NOTICE OF ERROR  
REPLY

Water right number: ~~32-8333~~ 32-833K

Re: Notice of Error-Water Rights Valley Club Inc.  
37-2623, 37-494, 37-657B, 37-495, 37-833K, 37- 0577BU, 37-057BV

**VALLEY CLUB II**  
**2006 Irrigation calculation**  
**NAIP 2006 Aerial photo**

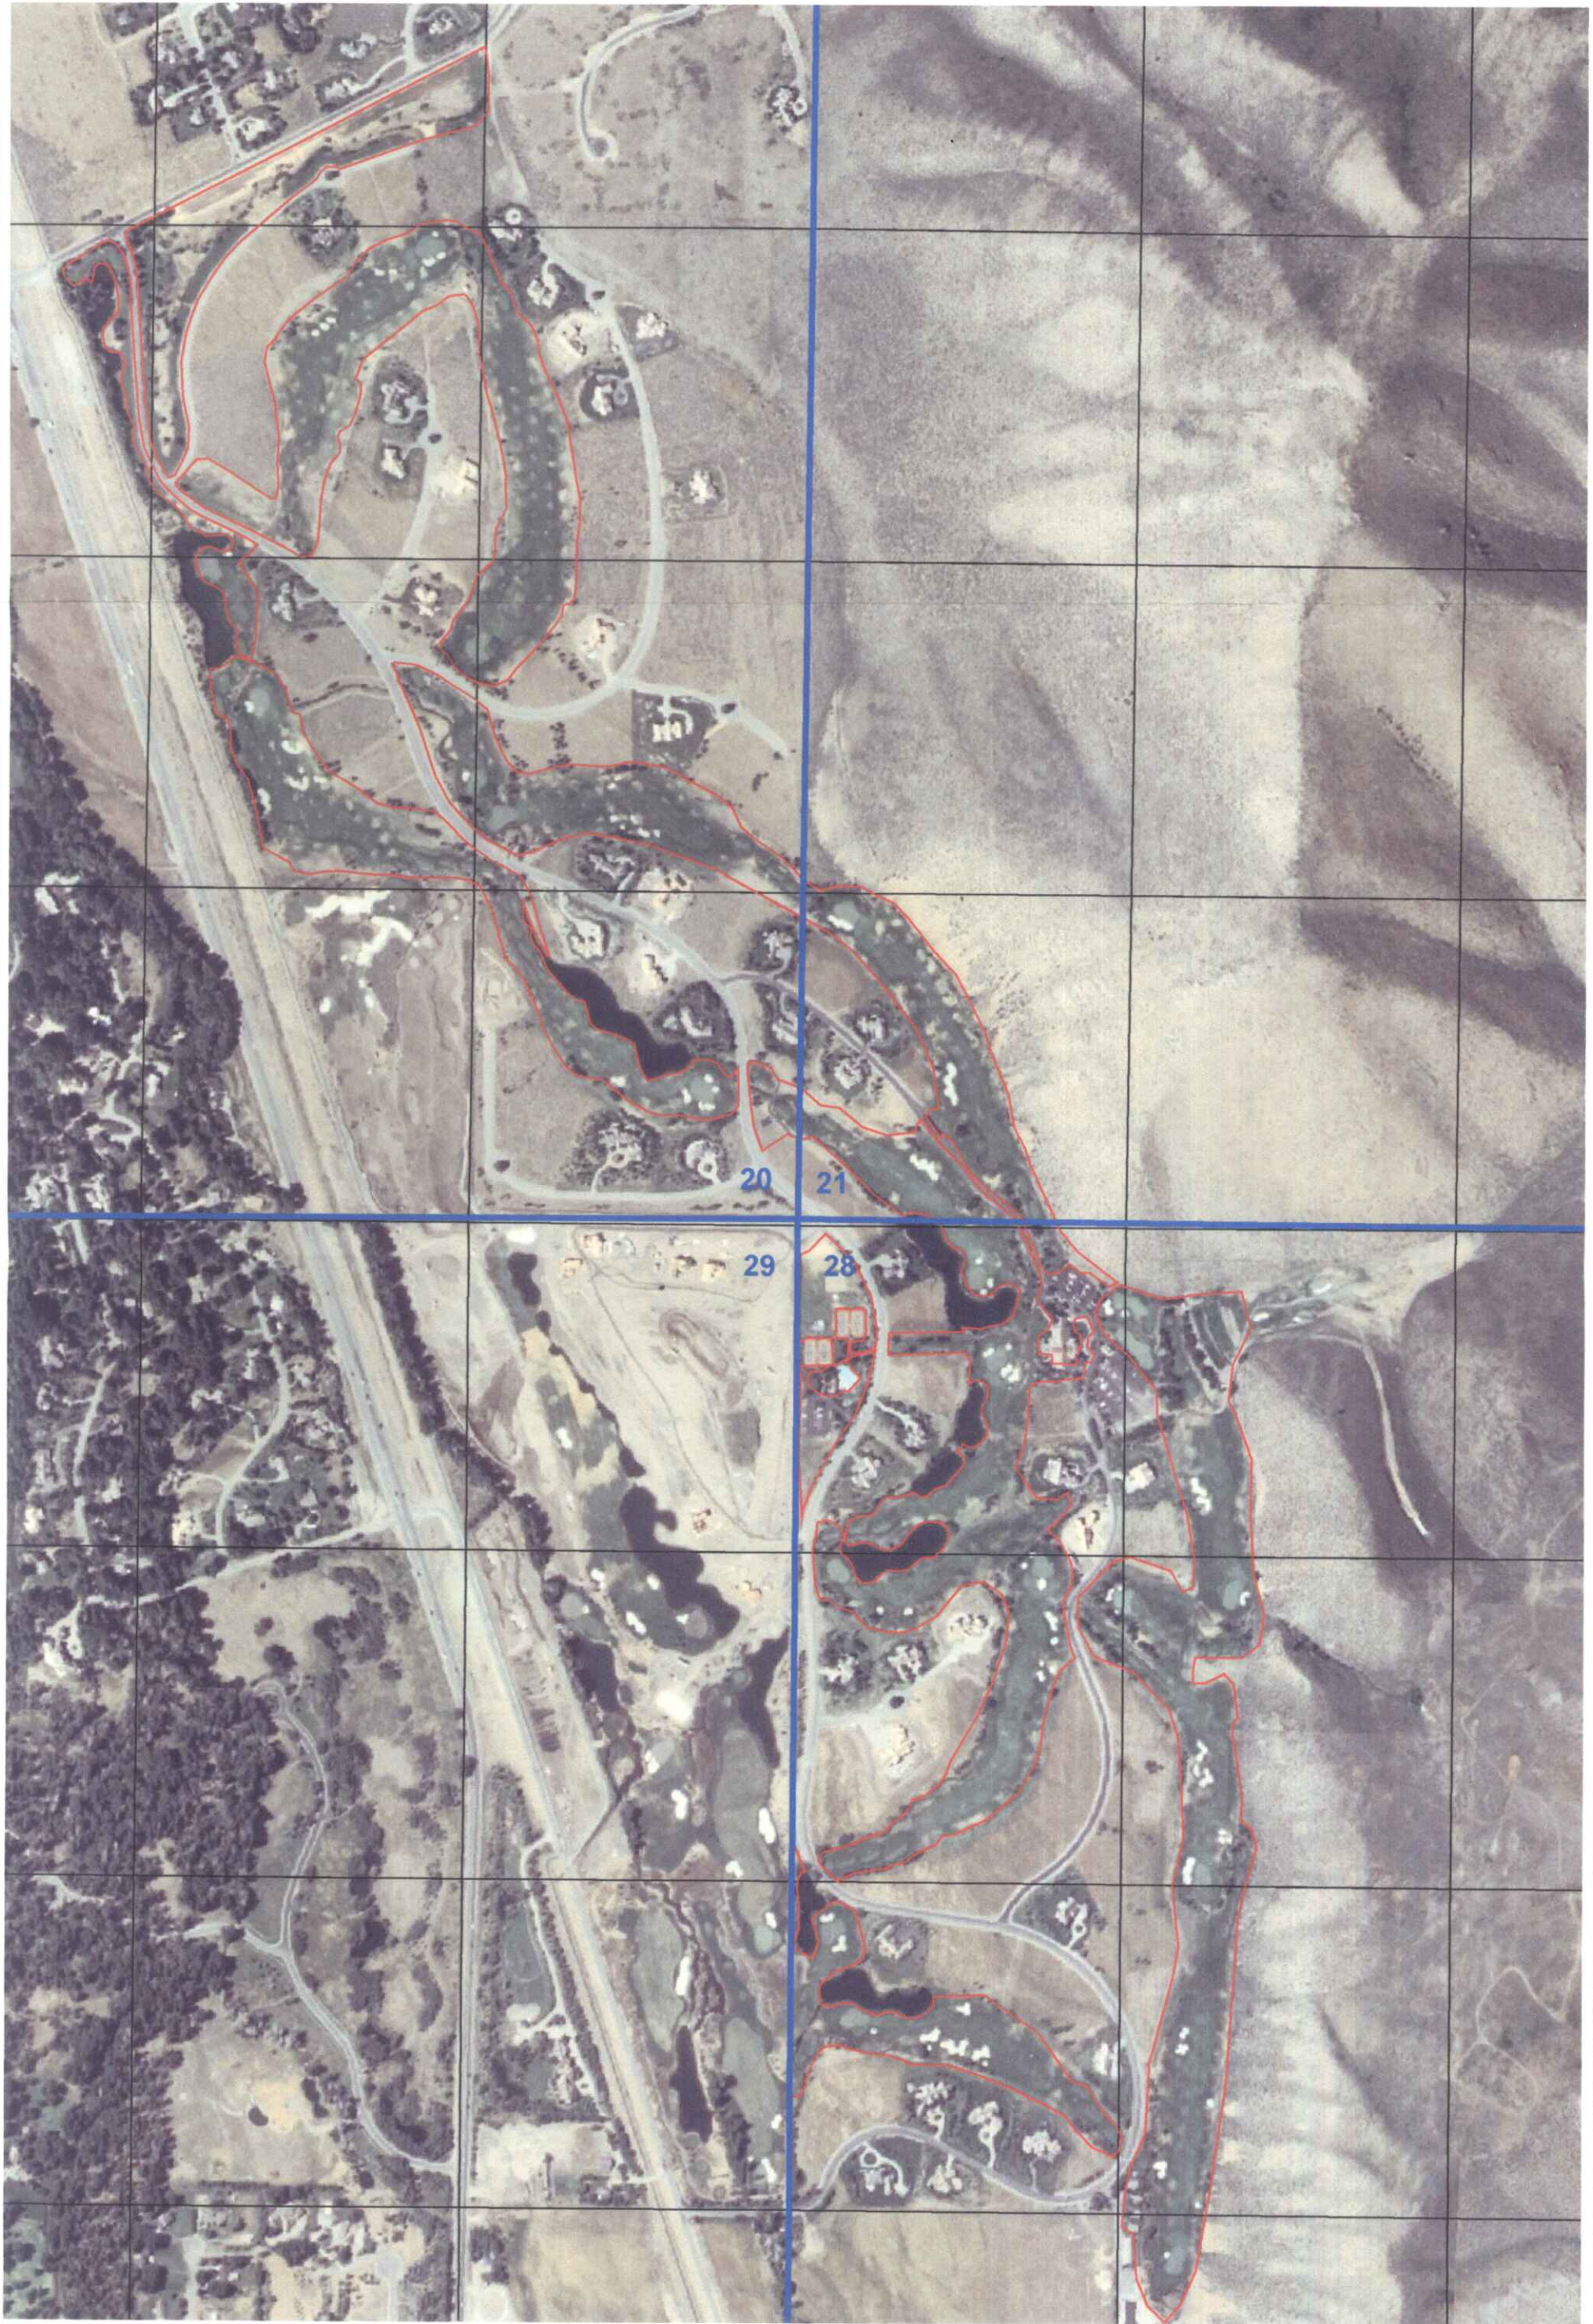
| Water Right No. | Disagreement                                                                   | Reason                                                                              |
|-----------------|--------------------------------------------------------------------------------|-------------------------------------------------------------------------------------|
| 37-2623         | Recommended Acreage<br>120.7 ac. recommended, should<br>be 143.8 ac.           | IDWR .shp file is<br>incorrect<br>See attached table and<br>Brockway Engr .shp file |

Sum = 144.6 acres  
Claim = 143.8 acres  
Pre. Rec.= 120.7 acres
